FMG. INC. 3700 Sturgis Road, Rapid City, South Dakota 57702-0317 605/342-4105
FAX 605/342-4222

RE: TRUCK ROUTE DBDP

**SOUTH TRUCK ROUTE
 DRAINAGE BASIN DESIGN PLAN
 RAPID CITY, SOUTH DAKOTA**

Revision / Date
 Sheet Number
**DESIGN PLAN
 SCHEMATIC
 WITH OPTION
 OF ELE. 13
 ALONG 5TH
 STREET**
 Figure Number
AG1

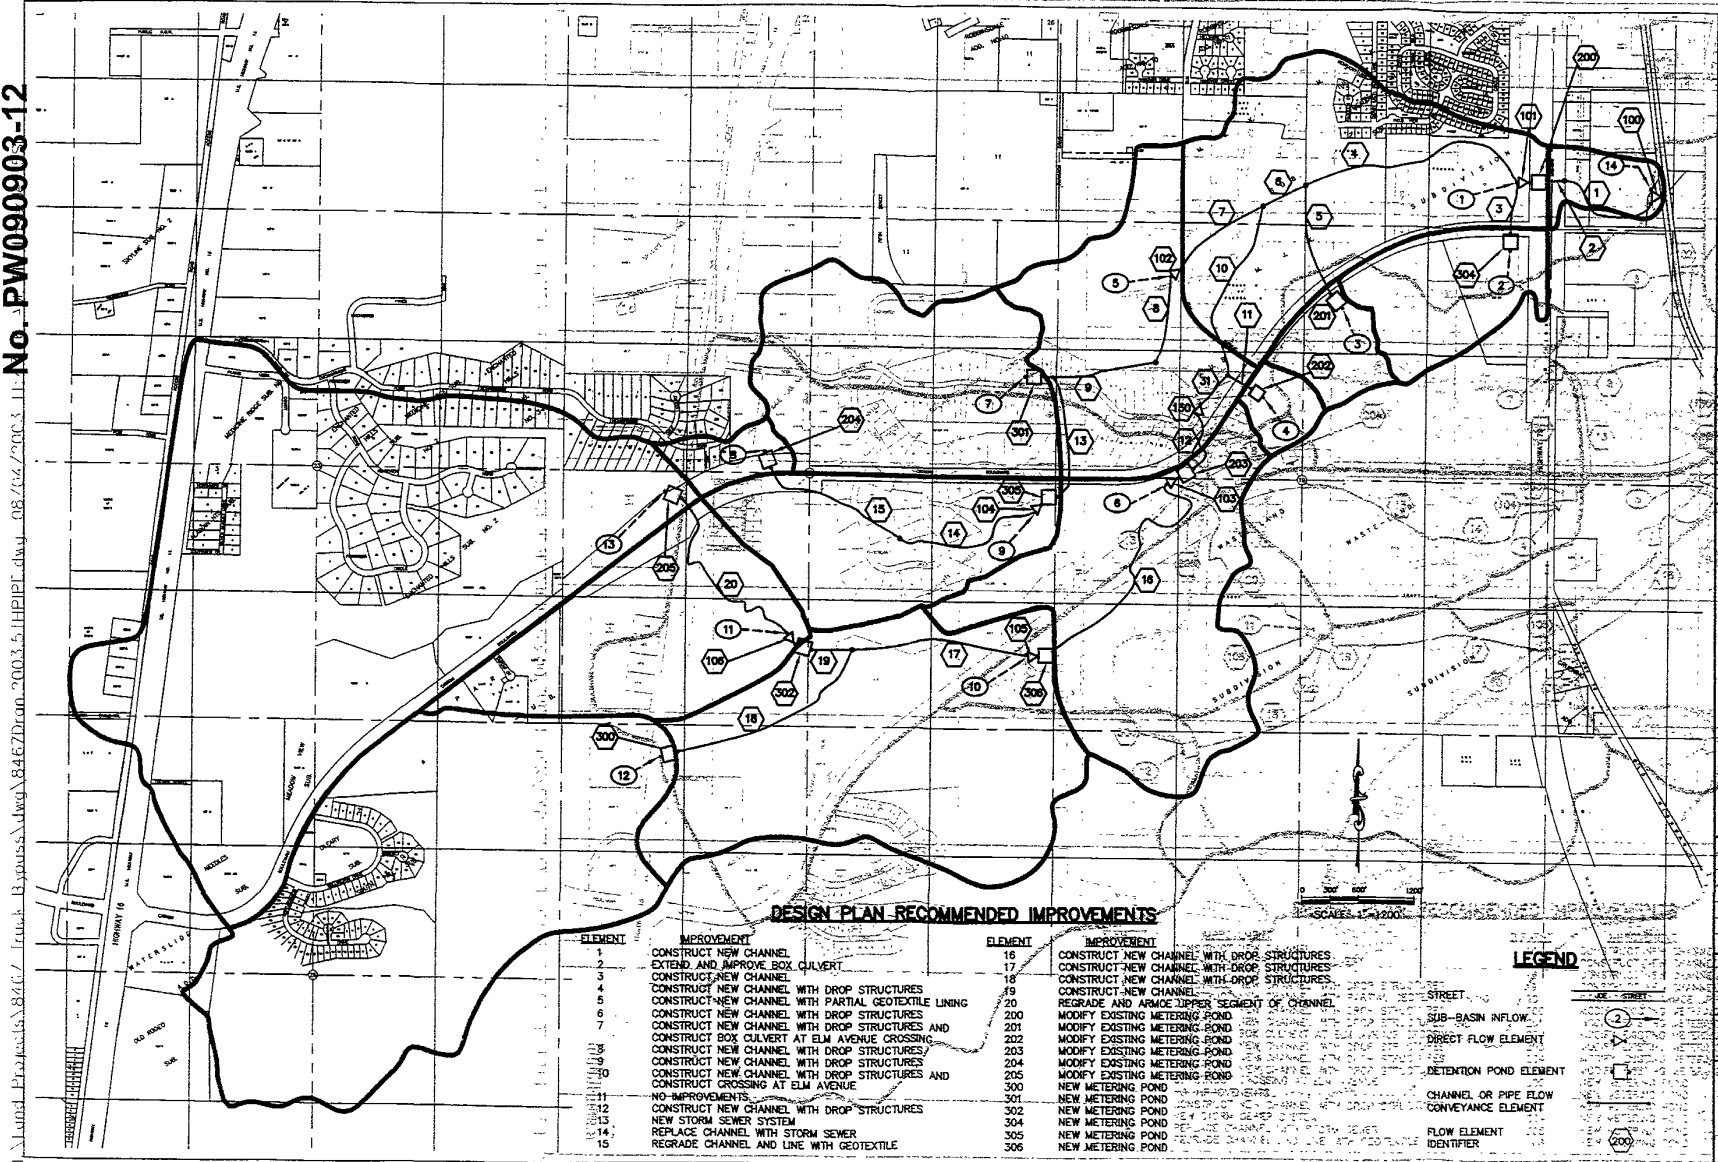
Per your request we have looked at another option on the Truck Route DBDP. This option is a modification of the draft DBDP submitted on July 3, 2003. The option follows the routes shown on Figure 3 in the July 3, 2003 submittal with the exception that Element 13 is proposed as a storm sewer pipe to connect the Element 305 Pond to the upstream end of the Element 9 channel. A schematic of the routing for this option is attached to this letter as Figure AG1.

It was also assumed the Pond 305 would be per the draft Design Plan Optional Routing. Under that option the discharge from Pond 305 is 89 cfs.

Based on a normal depth analysis the proposed pipe would be a 48" RCP. Capacity is about 100 cfs assuming an n value of 0.012. The pipe slope would be at 0.004 ft/ft. Pipe depth (to flow line from proposed road centerline) would range from about 10' to 16' deep.

Note that it will be necessary to drop the proposed 15" sewer elevation about 1 foot from that shown on the preliminary 5th Street plans prepared by Ferber Engineering. This will allow the 48" RCP to cross over the sanitary sewer with clearance of about 1 foot.

About 1000 feet of 48" pipe would be required. Based on the City of Rapid City estimating guide the cost of this pipe is about \$110.00 foot. Total estimated cost of the pipeline would likely be on the order of \$200,000.00 when adding items for the connection to the upstream cow pass, outlet end section, cradles at the sewer crossing, bends, outlet erosion protection, deep installation, lowering of the proposed 16" water main at storm sewer crossings, etc.

An option that could be considered is having Pond 305 per the draft DBDP with 216 cfs out. This would require an increase in the pipe size to 66" RCP. This pipe would cost significantly more than the 48" RCP.
